DETAILED ACTION

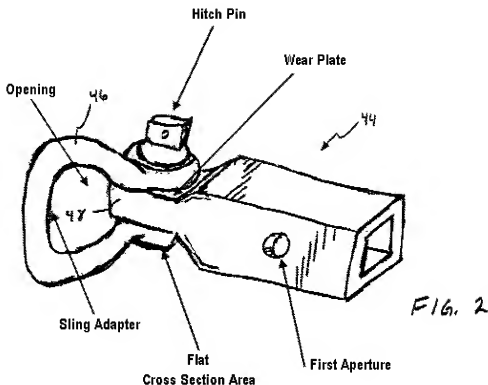
Lloyd discloses a hitch assembly [*adapter*] (44) [see included Fig. 2 below] for mounting into a hitch receiver (21) of a tow vehicle (Fig. 1) in order to tow a vehicle in need of towing, the hitch assembly (44) consisting essentially of: a coupling tongue [*elongate bar*] with a first end and a second end, the first end being received in the hitch receiver (21), the coupling tongue further comprising a first aperture sized to engage a coupling pin (31) (Fig. 1) at the first end, and a second aperture sized to engage a hitch pin at the second end; a U-shaped clevis [*D-ring*] (46) with a first clevis end and a second clevis end, that is substantially flat in cross section and consists of an aperture at the first clevis end and the second clevis end, the U-shaped clevis (46) being pivotally coupled to the second end of the coupling tongue with the hitch pin, and an opening formed by the coupling tongue and the U-shaped clevis (46), sized to receive a towing member [*i.e. ropes, chains and straps*] {Para [0030], Lines 3-5} that is also attached to the vehicle being towed; a wear plate [*mounting plate*] (48) located at both ends of the U-shaped clevis (46); and a sling adapter [*inner surface of U-shaped clevis (46) for contacting and bearing the load from the towing member*] being disposed in the U-shaped clevis (46) of the hitch assembly (44).
